Re: 50 Humberwood Boulevard - Settlement Offer

OMB Case No.: MM160045

Further to our meeting today, I wanted to summarize the settlement offer from the applicant.

Schedule B

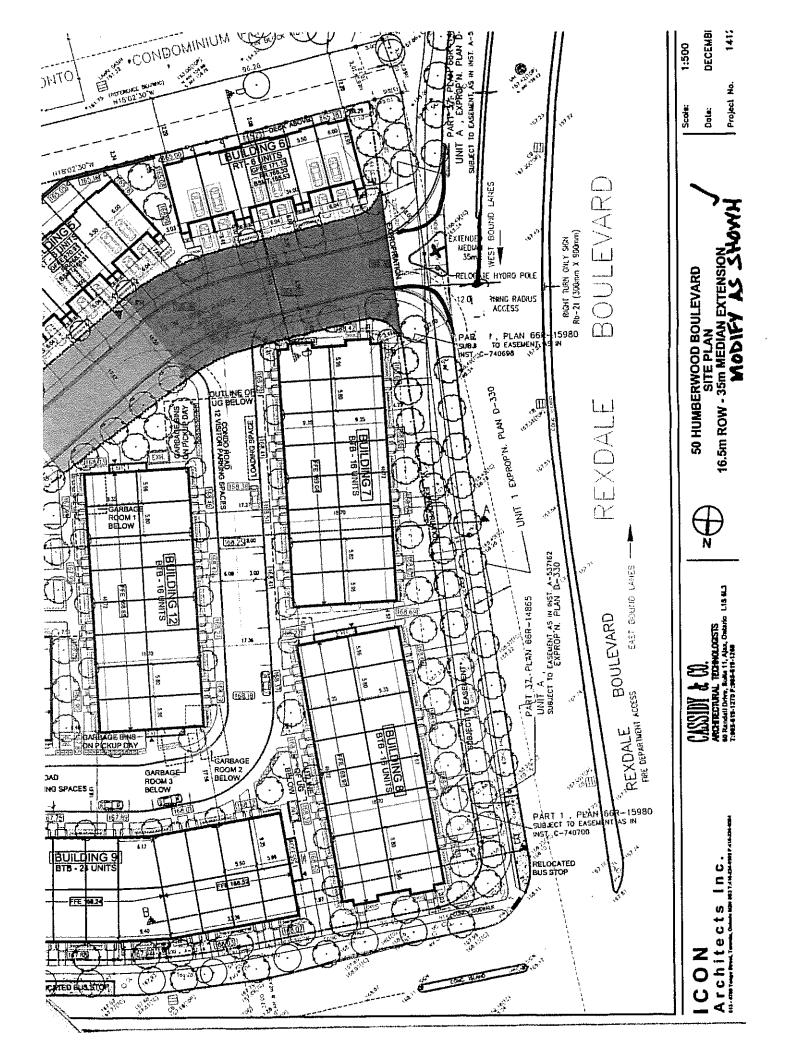
The applicant was asked to revise the width of the townhouses from 5.5 metres to 6 metres. Although this has resulted in the loss of units, the applicant is prepared to increase the width of the units to 6 metres. We note that the westerly unit in Building 1 has a width of 5.5 metres. This was done to create a continuous setback on Humberwood Boulevard. If the City wishes to have the width of this unit changed to 6 metres, the applicant is prepared to make that change and accepts that the setback on Humberwood Boulevard will no longer be continuous. All other freehold units are 6 metres wide. These widths are shown on the site plan attached as Schedule "B".

During the meeting, staff members indicated that they wished to see an increase in the spacing between Buildings 8 and 9 and between Buildings 11 and 12. The applicant has increased the separation to 11 metres which is shown on the site plan attached as Schedule "B".

parking of moving vehicles such that they will not impede traffic movement, including the movement of emergency vehicles. These areas are identified with the label "moving space" on the site plan attached as Schedule "B".

Schedule C

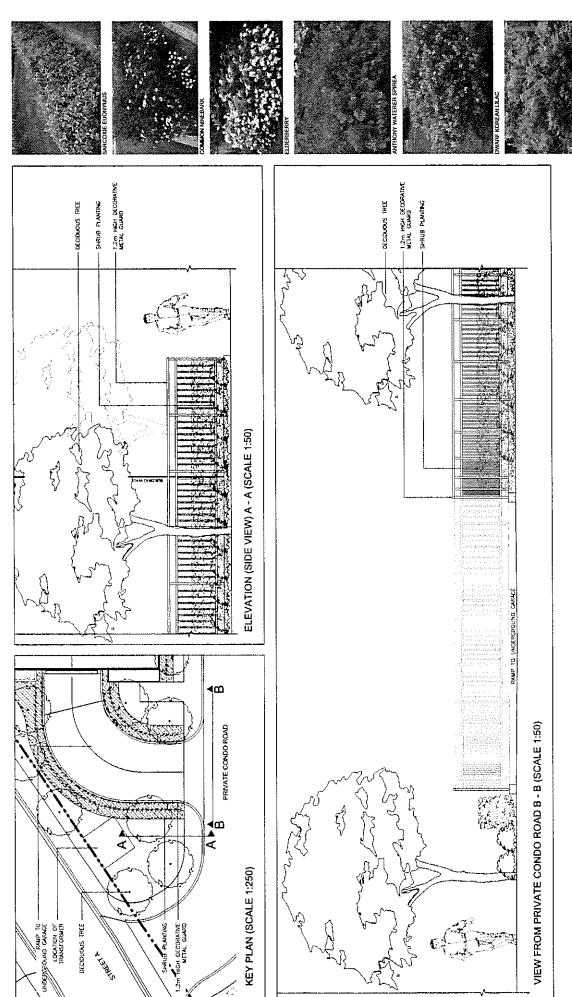
The applicant has evaluated two access options. The option shown on the attached plans involves a separate westbound right turn lane into the site. Since the time these drawings were prepared, City staff provided us with an alternative design which eliminates the separate westbound access lane and extends the median as shown on the City's sketch which is attached as Schedule "C".

As stated during the meeting, the applicant can accept the City's proposal shown in Schedule "C". The applicant is content with both options.

Schedule D

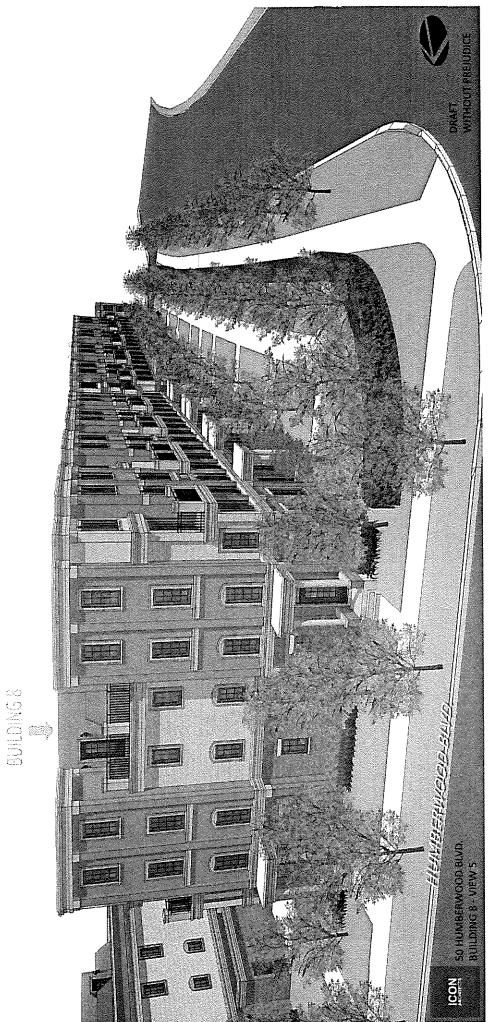
We have attached a sketch of the proposed screening as Schedule "D" to this letter.

BUILDING 7 - FRONT ELEVATION ON REXDALE

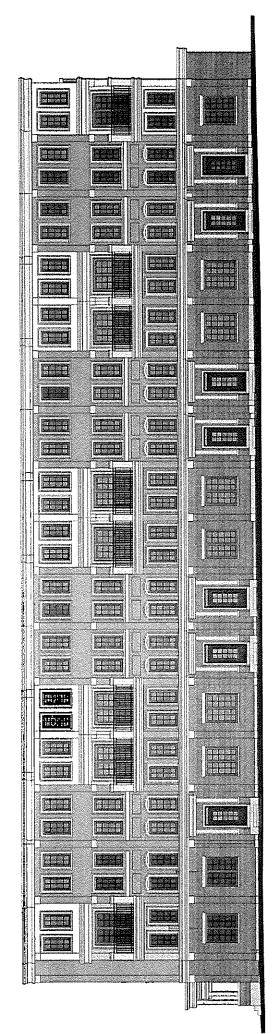
- 1. The design of the townhouses has been modified by moving certain mechanical space to the rooftop and massing that mechanical space towards Rexdale Boulevard. The mechanical space does not span the entire width of the unit and it is proposed that for the remainder of the width of the unit, an architectural treatment will be added which extends the south wall of the mechanical area in a continuous manner. This will give the appearance of a fourth storey. This approach has been illustrated in the conceptual elevations and associated plans attached as Schedule "E".
- 2. During the December 14th meeting, we discussed the inclusion of a private sidewalk and plantings to improve the relationship between the townhouses and Rexdale Boulevard. This is shown on the site plan attached as Schedule "B".

The applicant is prepared to proceed to the Ontario Municipal Board with the plans as shown in the attached Schedules. We note that the elevation is conceptual and if the approach of the architectural treatment and mechanical room location is acceptable to the City, the elevations will be refined.
